**BRICKYARD ESTATES, ADMINISTRATIVE SUBDIVISION PLAN  
NO. 620230150 AND PRELIMINARY / FINAL FOREST  
CONSERVATION PLAN NO. F20230390**

No. 620230150 & F20230390

MCPB Item No. 13

Date: 2-29-2024

Figure 4 - Administrative Subdivision Plan

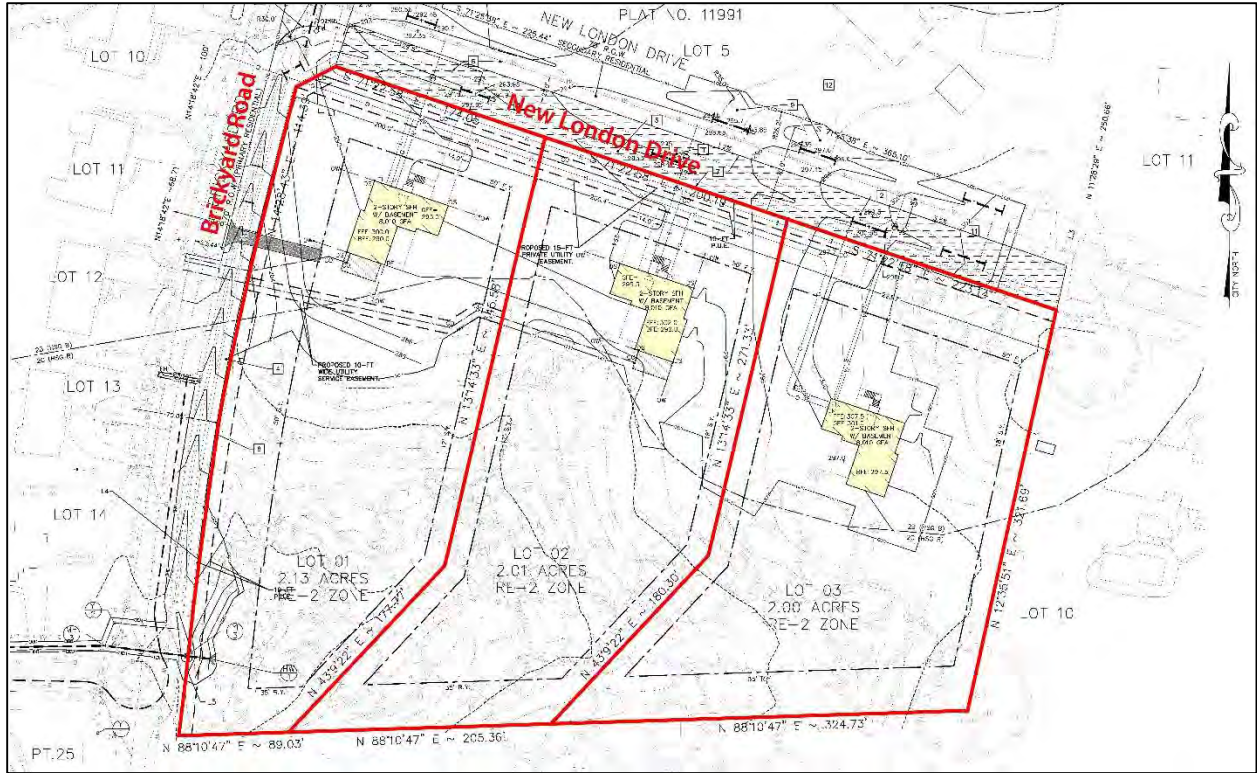
3. On the certified plan, remove all references to the concrete channel shown on the Brickyard Road cross section on Sheet 07-ADSUB-006.

## FIRE ACCESS PLAN

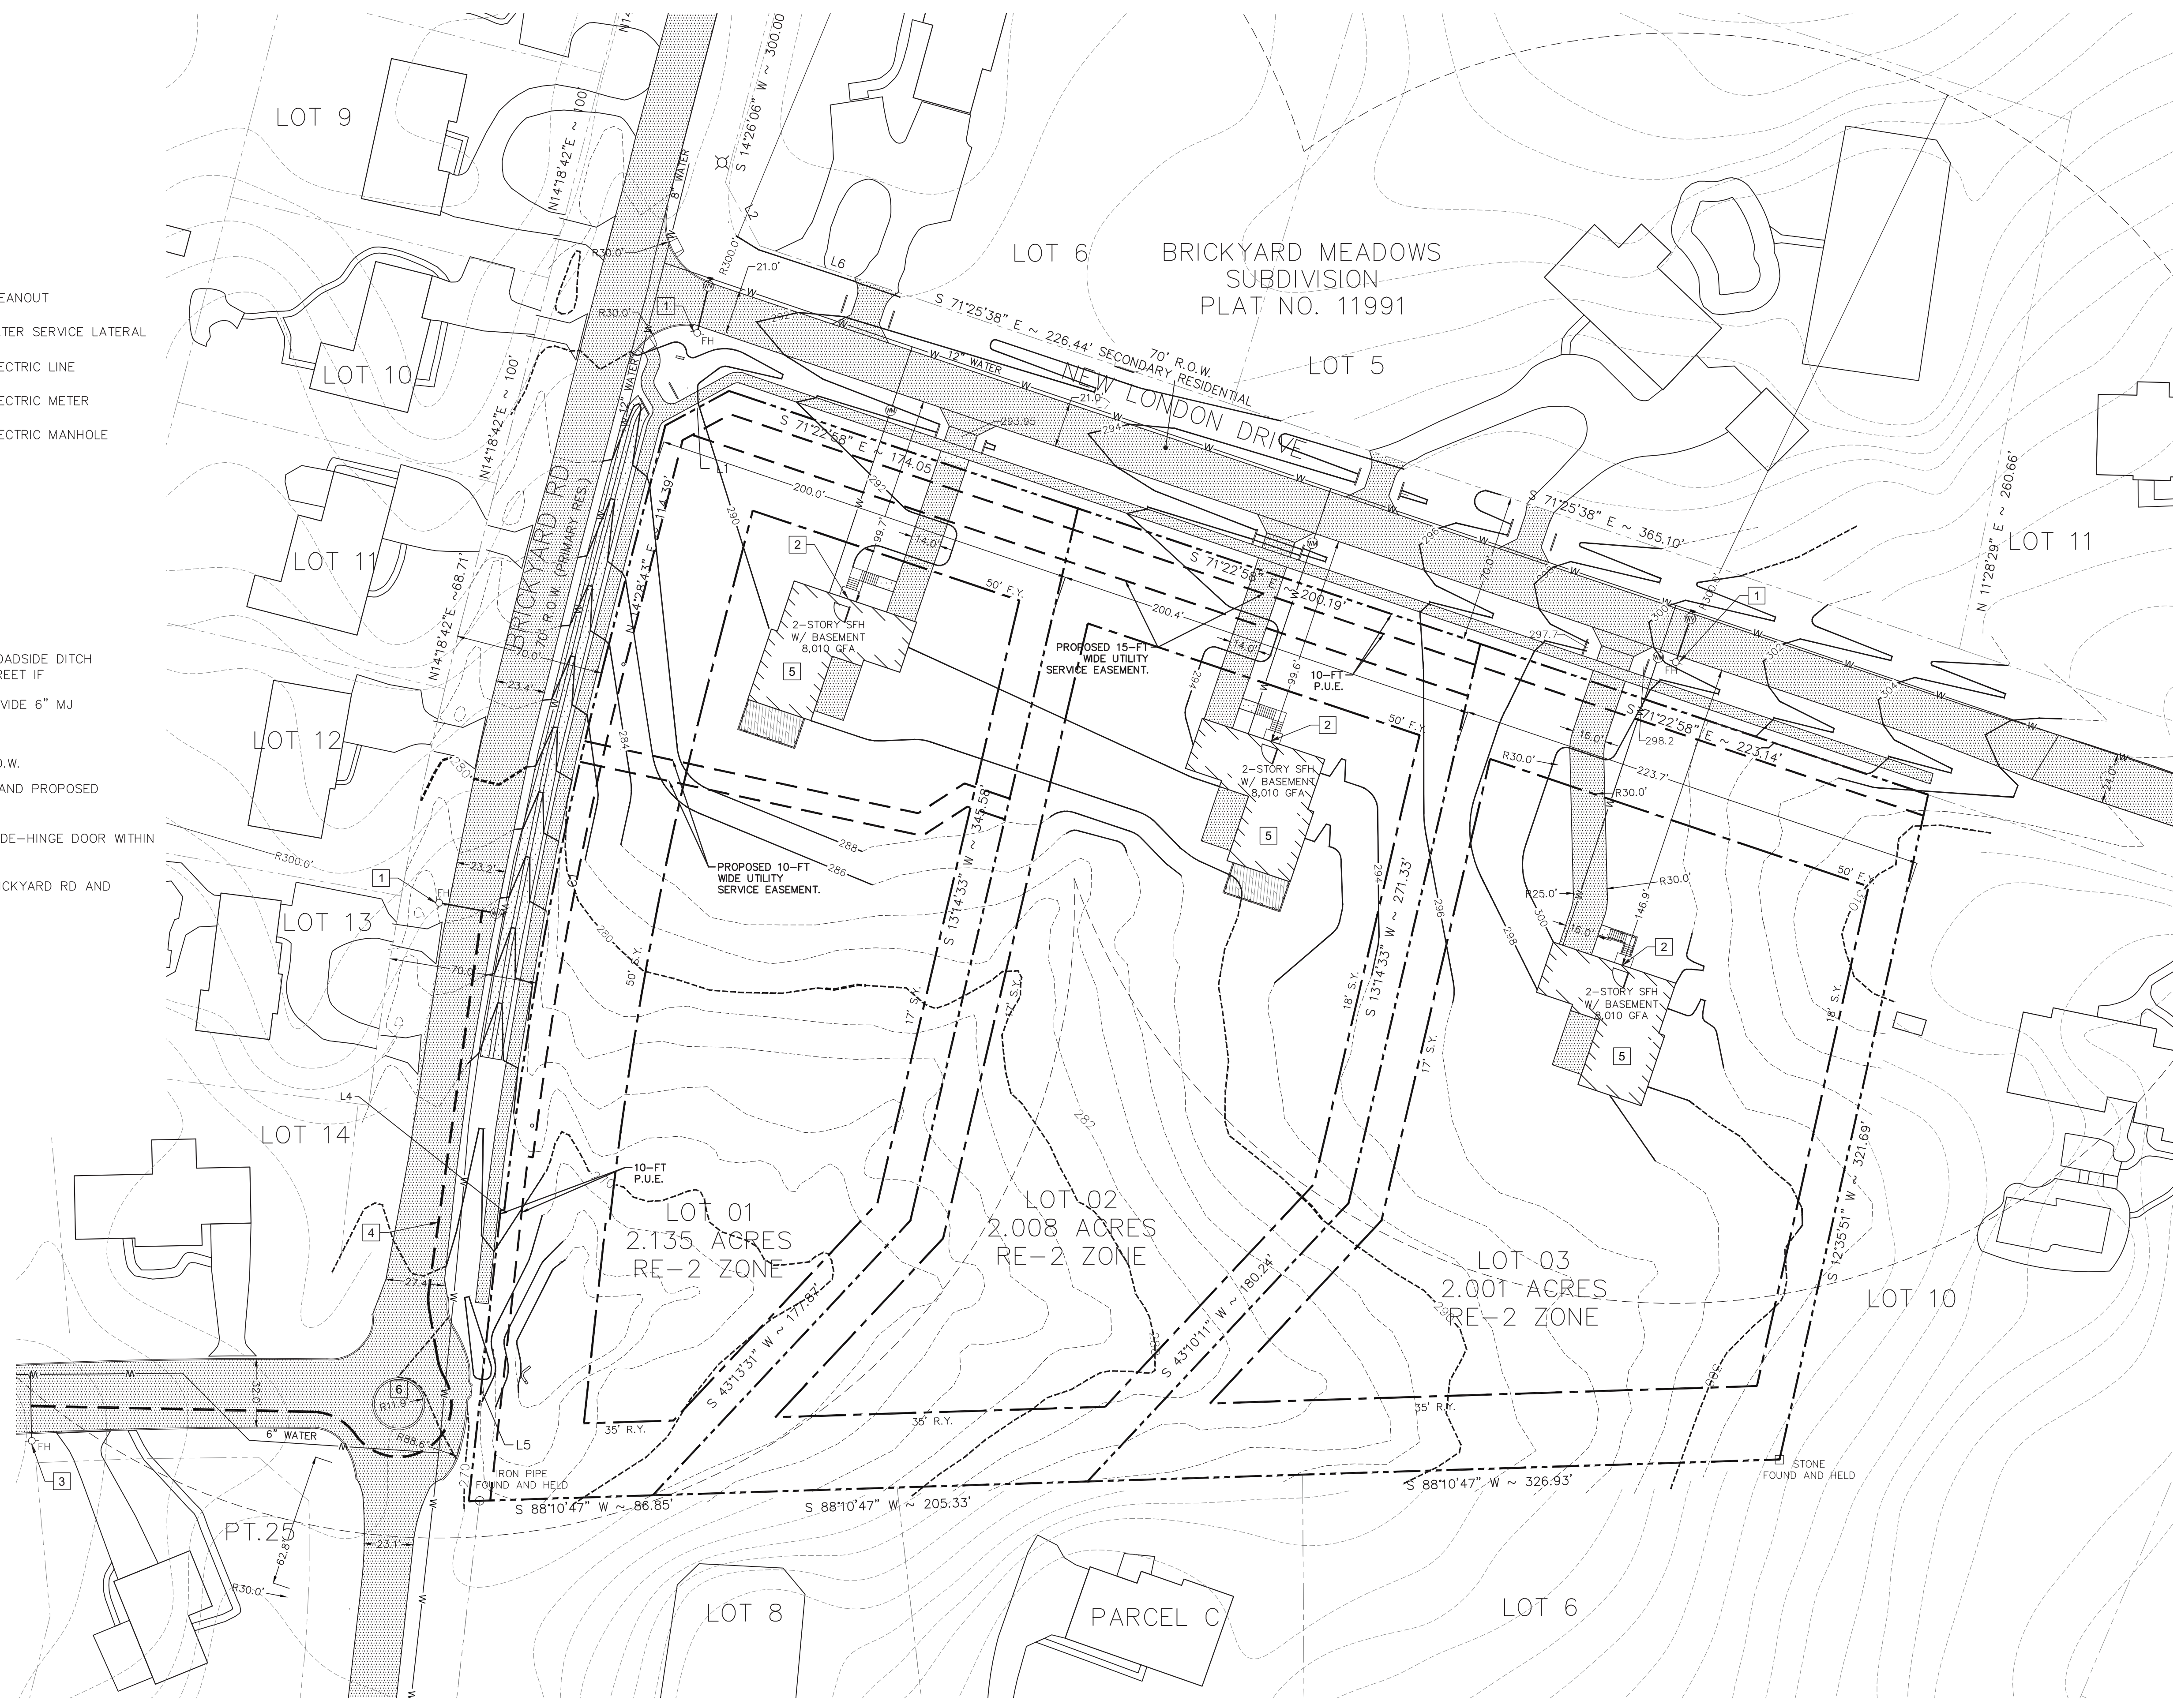
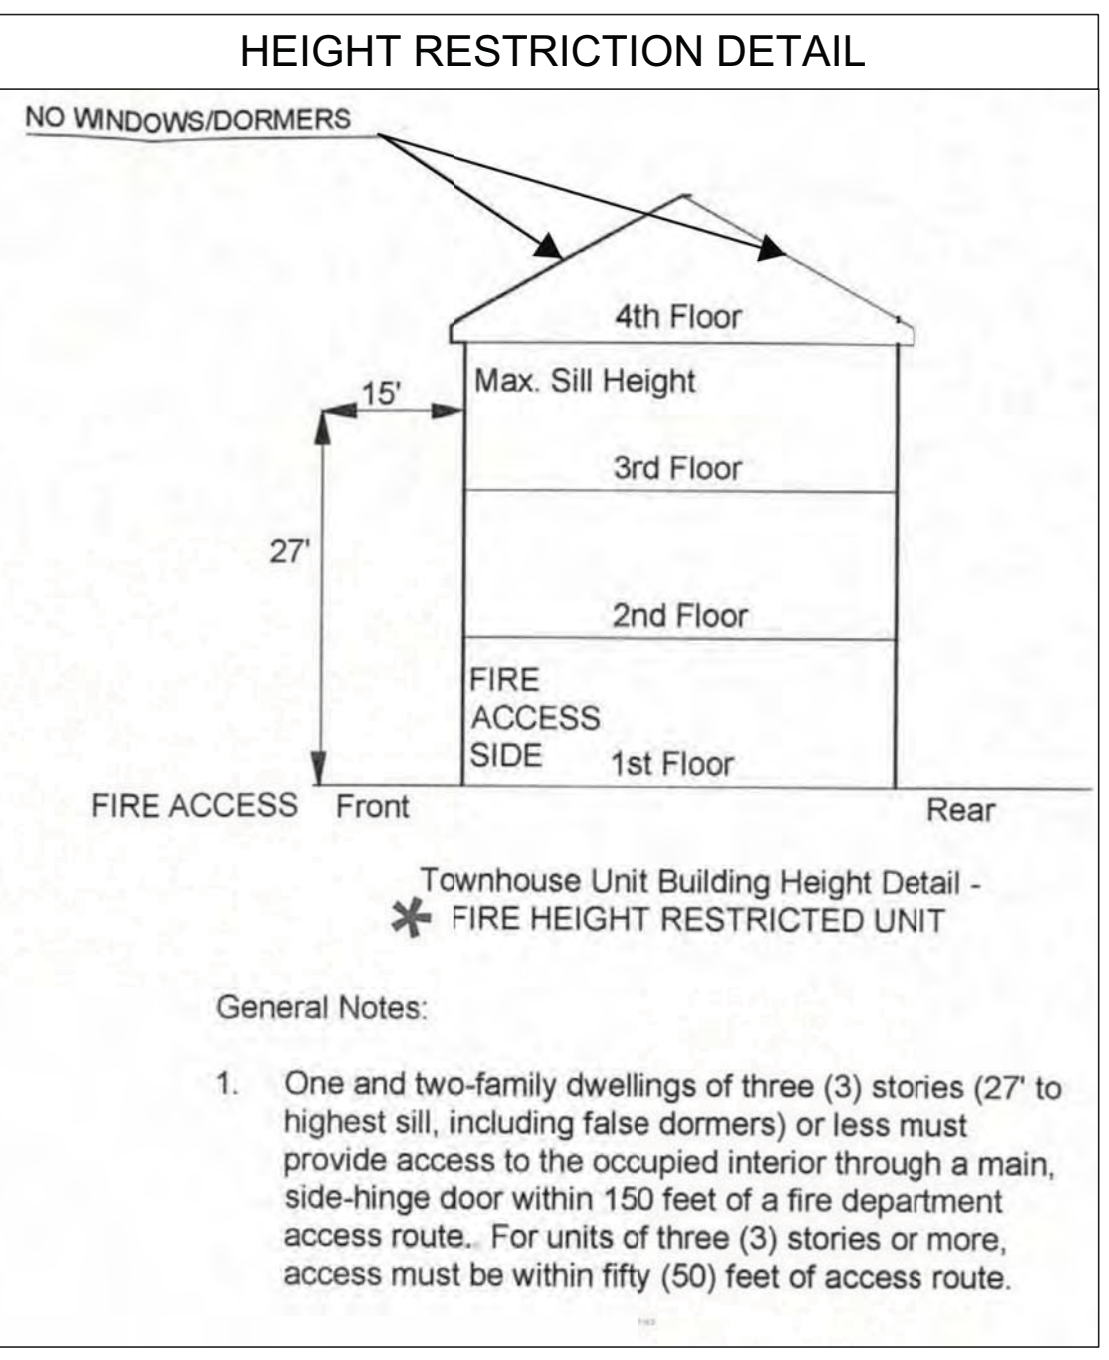
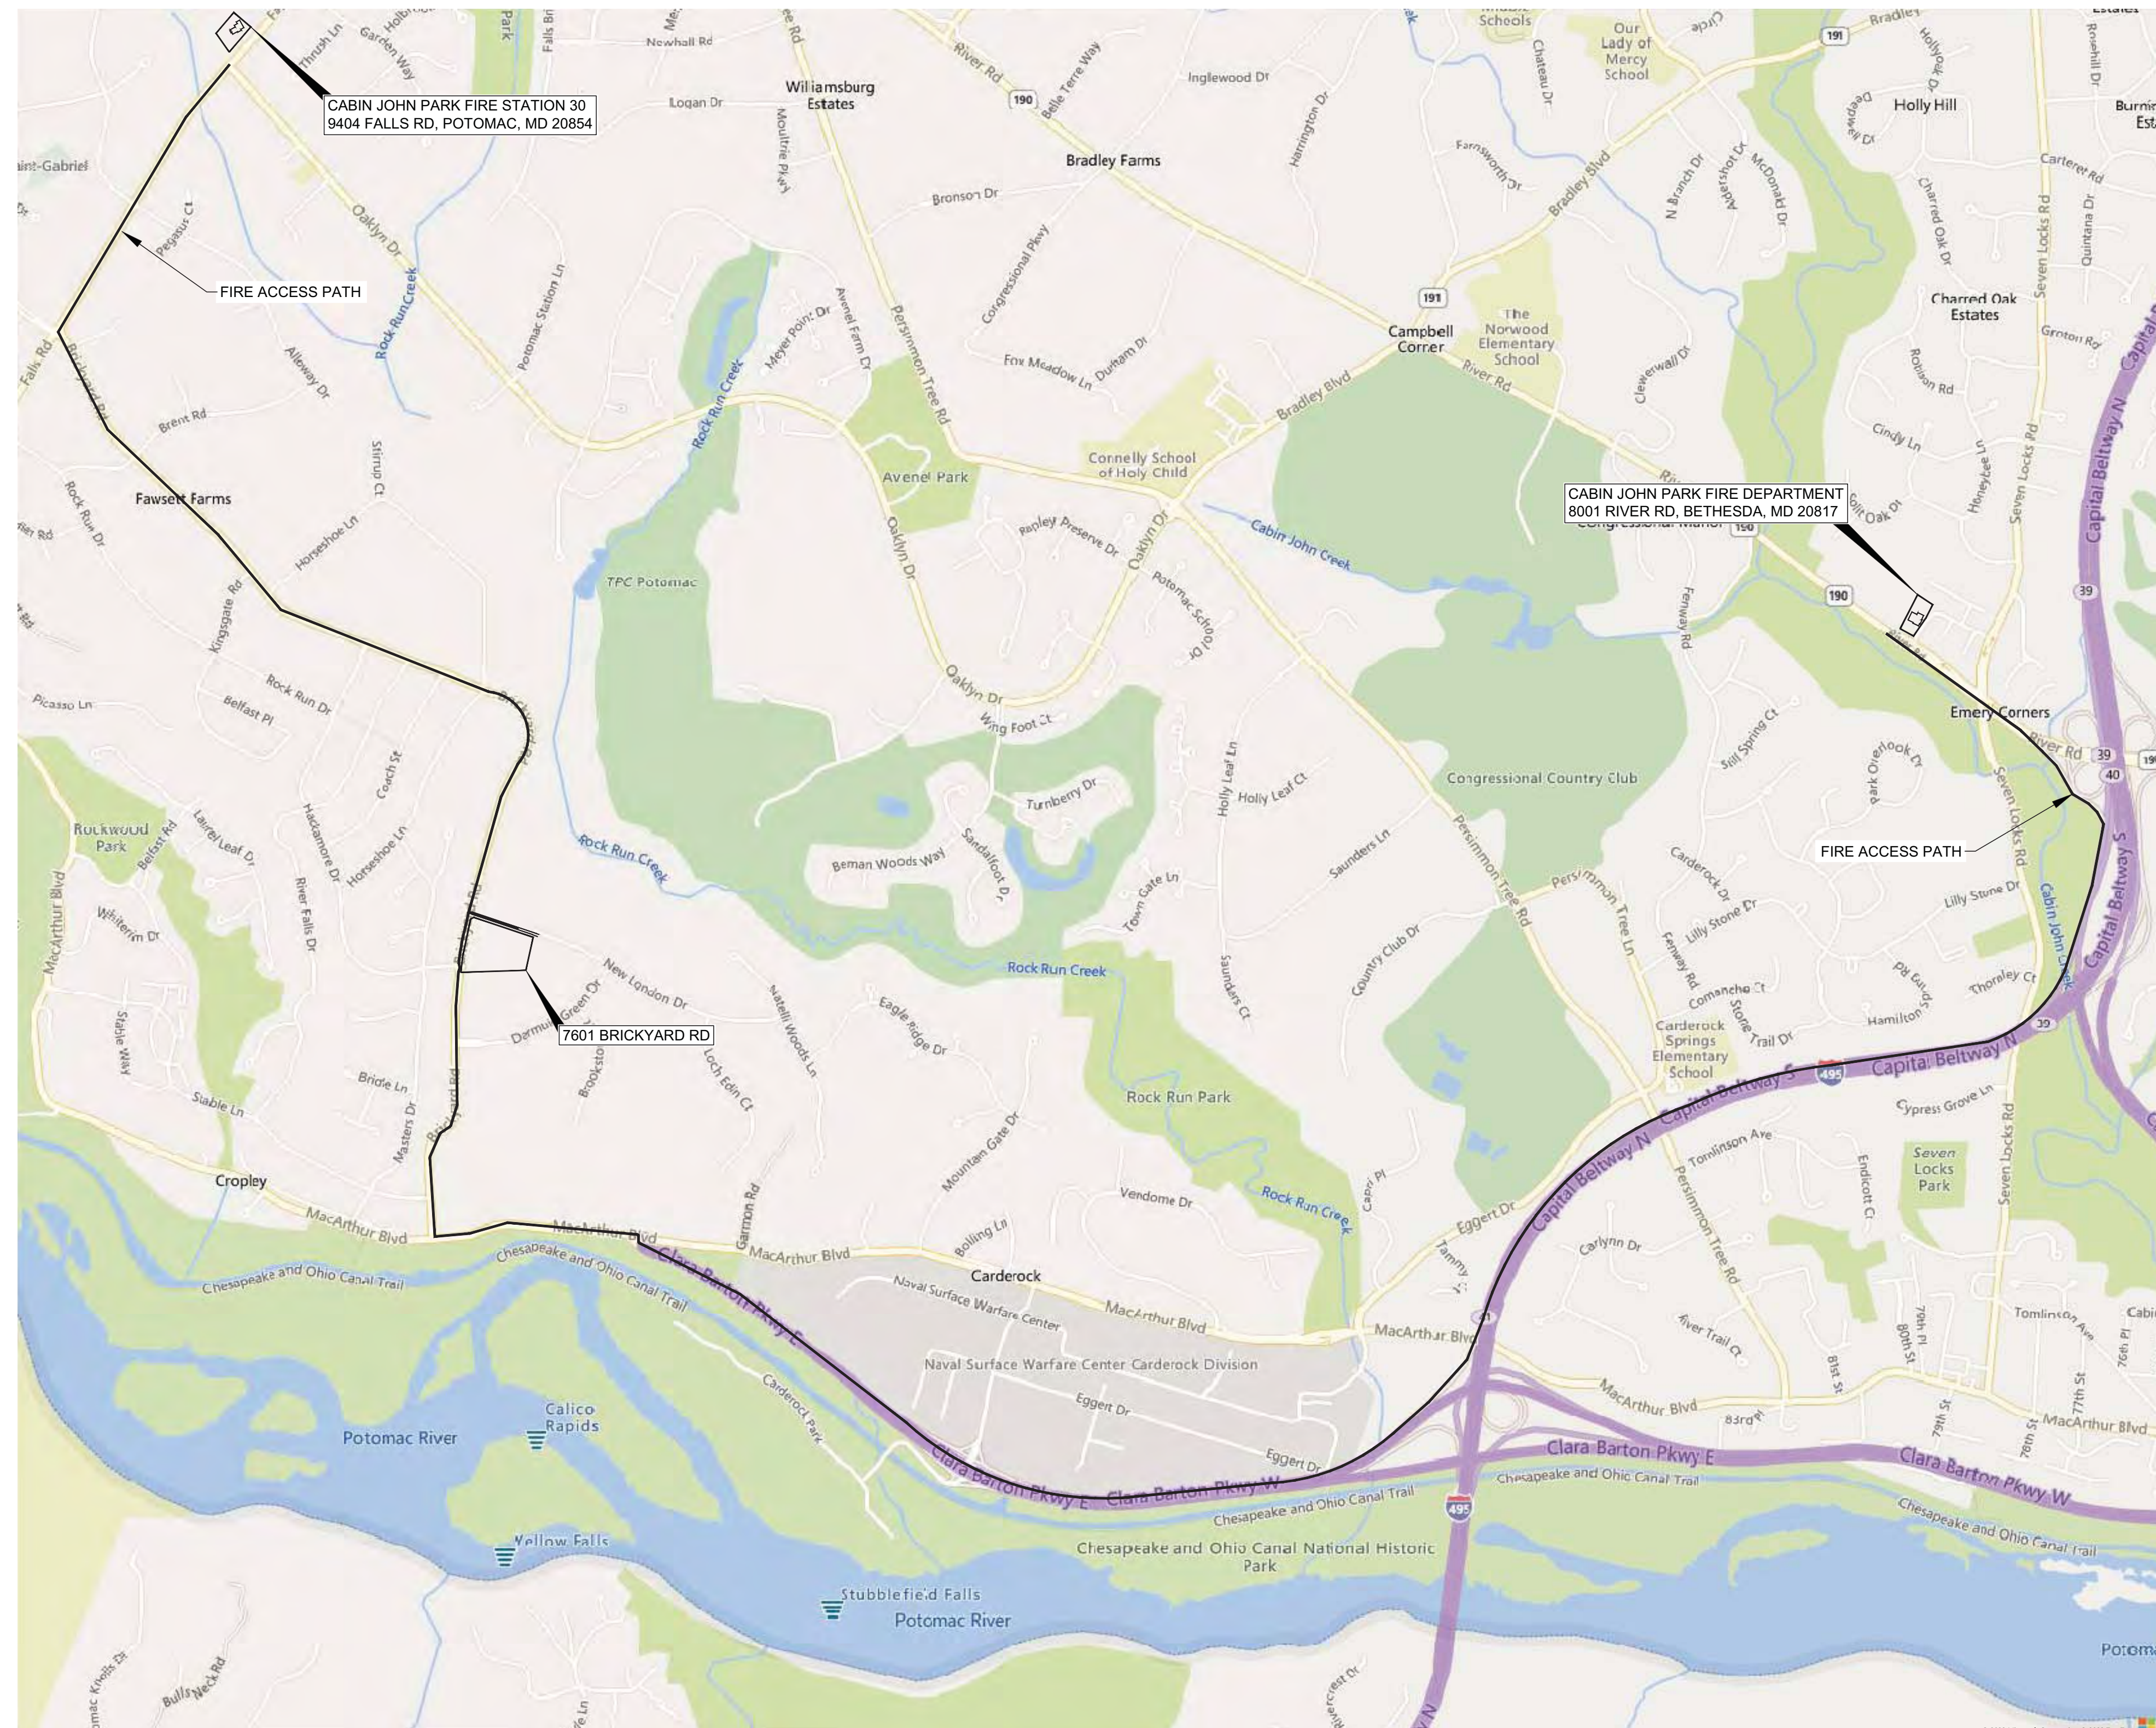
- FIRE ACCESS PLAN KEYNOTES**
- NEW FIRE HYDRANT LOCATED OUTSIDE OF PROPOSED CONCRETE ROADSIDE DITCH AND 3' OFFSET ROAD SURFACE OR ON THE OPPOSITE SIDE OF STREET IF LOCATION IS NOT POSSIBLE. CONNECT TO EXISTING 12" WATER MAIN WITH 12"x6" TEE AND PROVIDE 6" MJ VALVE (WSSC STD. W-8.1)
  - PRINCIPLE BUILDING ENTRANCE
  - NEAREST EXISTING FIRE HYDRANT LOCATED IN HACKMORE DR. R.O.W.
  - 457 LF TRAVEL PATH BETWEEN NEAREST EXISTING FIRE HYDRANT AND PROPOSED FIRE HYDRANT
  - ALL NEW STRUCTURES TO BE HEIGHT RESTRICTED TO 3-STORIES (27' TO HIGHEST SILL) AND PROVIDE ACCESS THROUGH A MAIN, SIDE-HINGE DOOR WITHIN 150' OF A FIRE DEPARTMENT ACCESS ROUTE. SEE HEIGHT RESTRICTION DETAIL ON THIS SHEET
  - EXISTING NON-COMPLIANT CONDITION AT THE INTERSECTION OF BRICKYARD RD AND HACKMORE DR

- FIRE ACCESS PLAN NOTES**
- THE LAYOUT SHOWN ABOVE SHOWS THE PROPOSED NEW LONDON DRIVE EXPANSION CONNECTING THROUGH TO THE EXISTING NEW LONDON DRIVE
